ADDENDUM NO. 3

Reference: New Facilities/Planning Center
Utah Valley University – Orem, Utah
Project No.09247790

Subject: **Addendum No. 3**

SHEET TITLE
**SECOND LEVEL
 MECHANICAL ALTERNATE
 FLOOR PLAN**

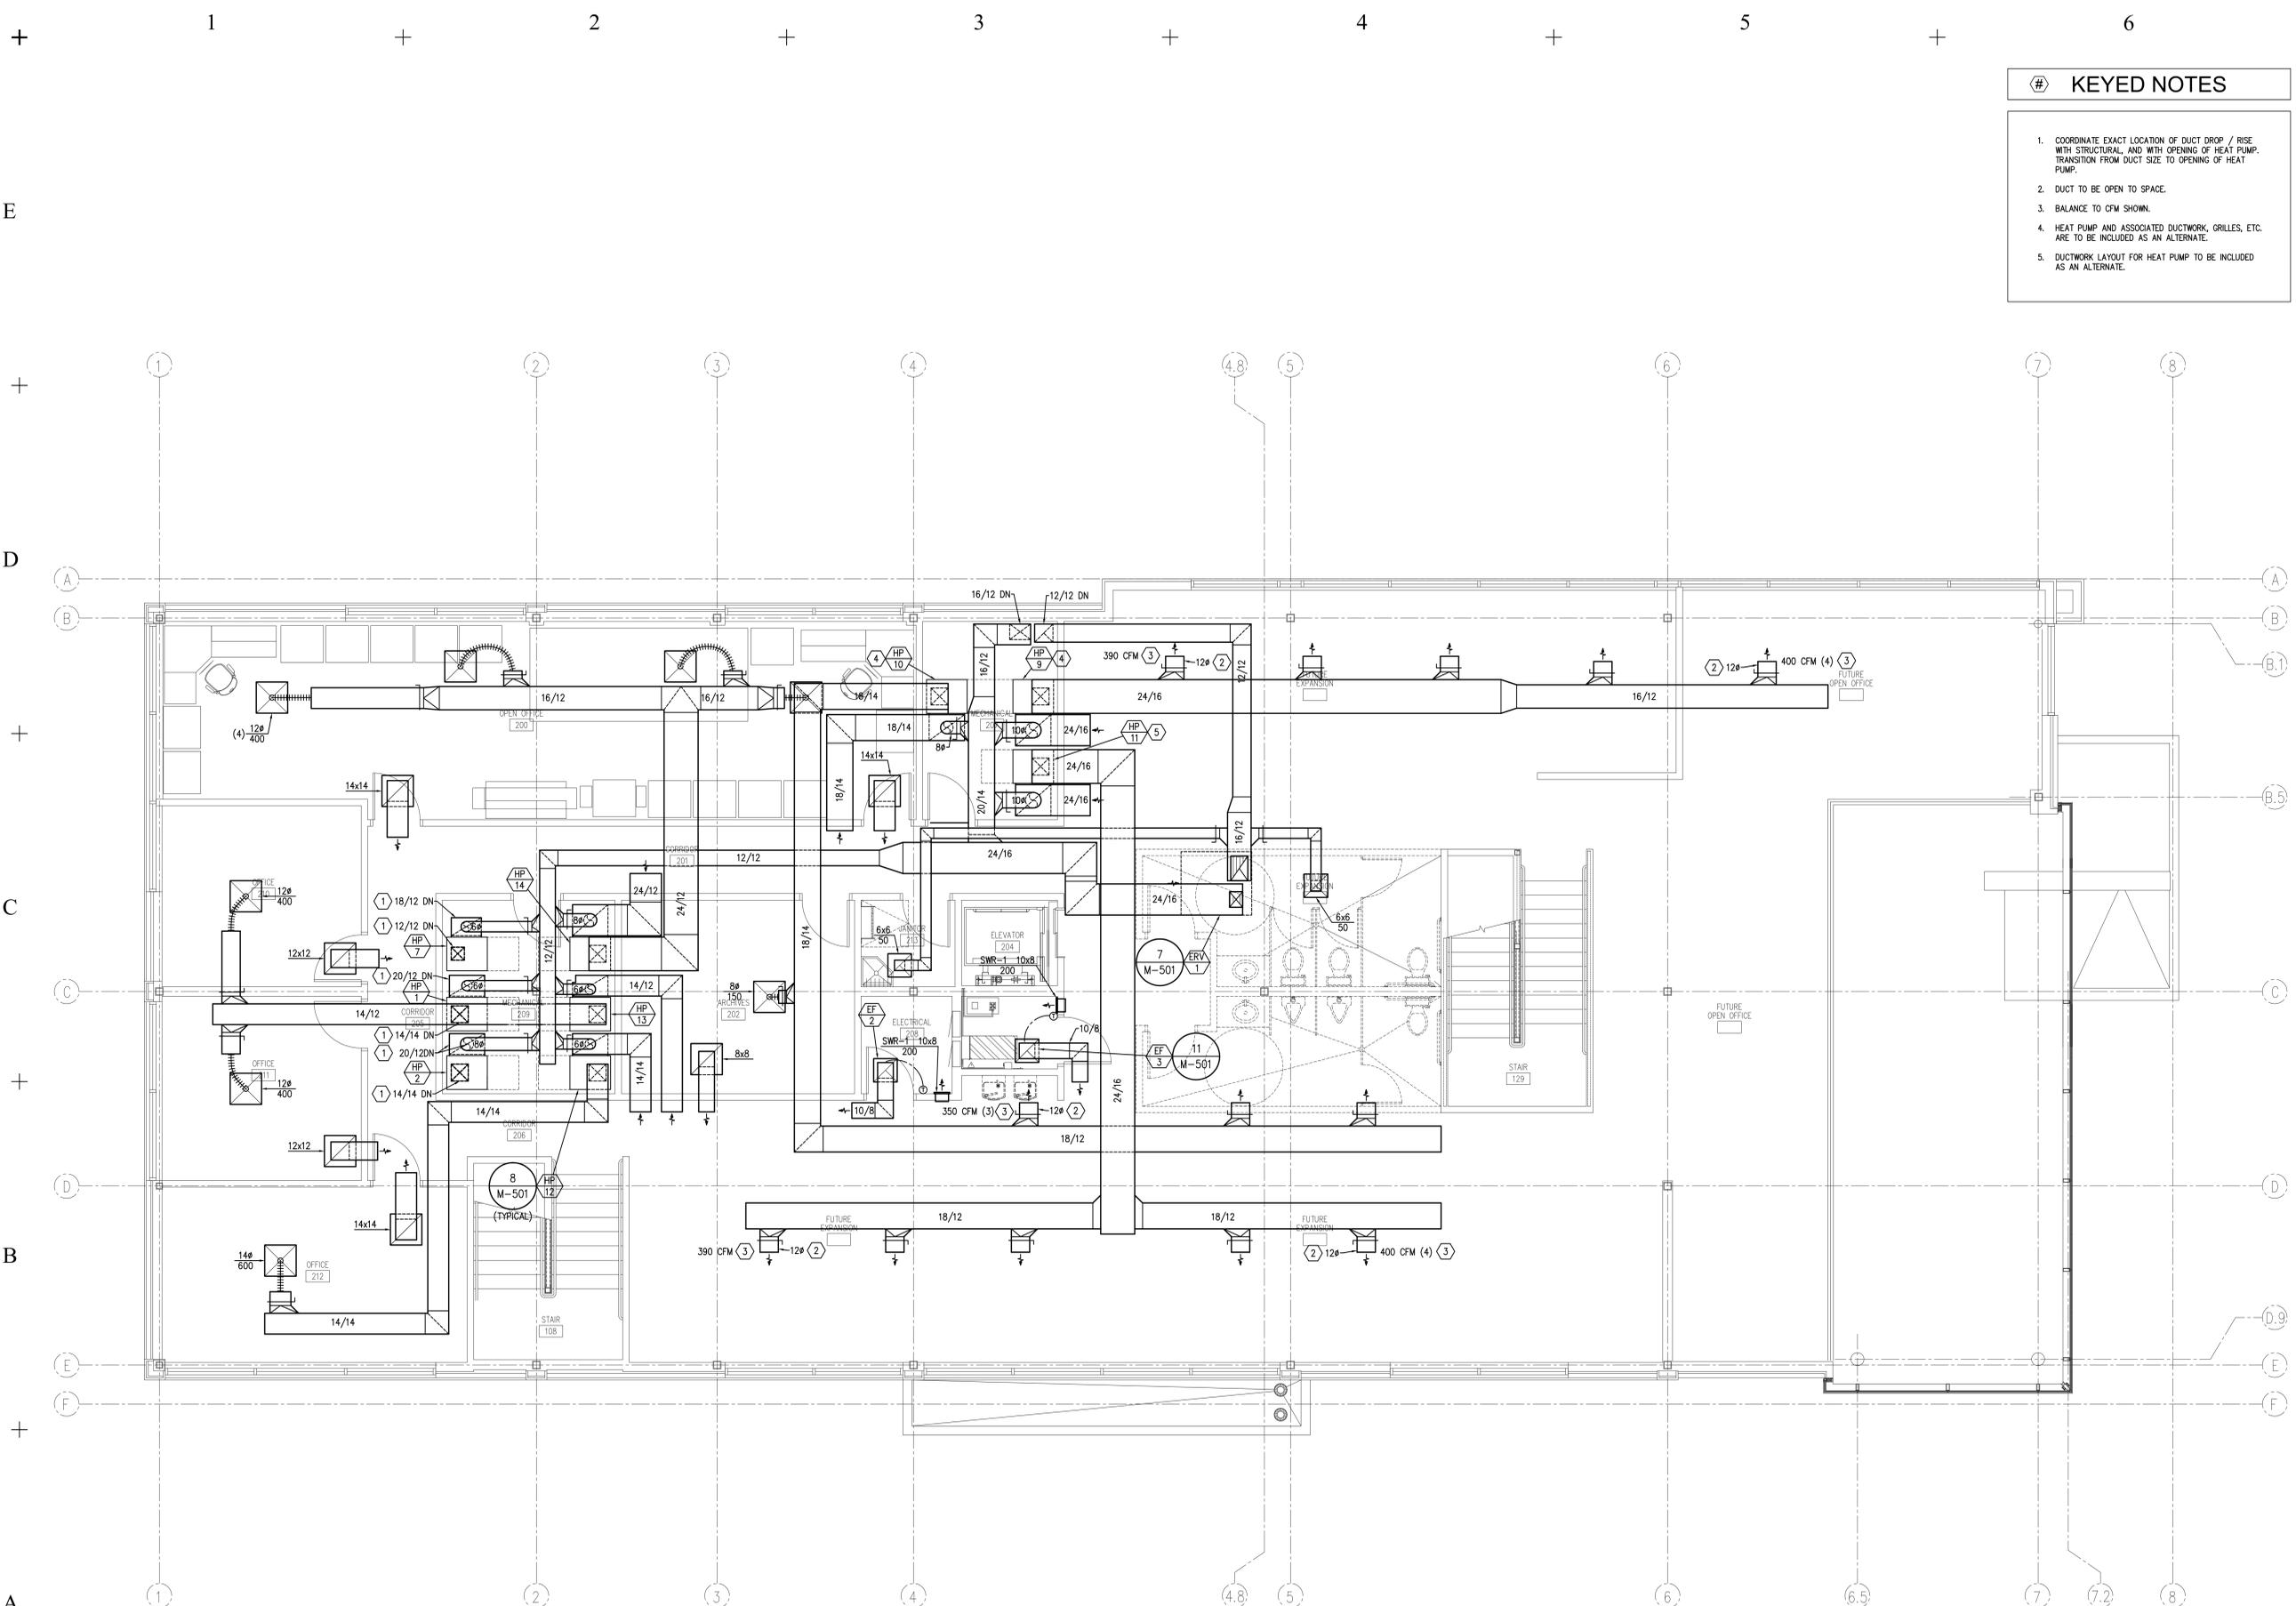
3.2 GENERAL – Mechanical Drawings

- KEYED NOTES**
- COORDINATE EXACT LOCATION OF DUCT DROP / RISE WITH STRUCTURAL AND WITH OPENING OF HEAT PUMP. TRANSITION FROM DUCT SIZE TO OPENING OF HEAT PUMP.
 - DUCT TO BE OPEN TO SPACE.
 - BALANCE TO CFM SHOWN.
 - HEAT PUMP AND ASSOCIATED DUCTWORK, GRILLES, ETC. ARE TO BE INCLUDED AS AN ALTERNATE.
 - DUCTWORK LAYOUT FOR HEAT PUMP TO BE INCLUDED AS AN ALTERNATE.
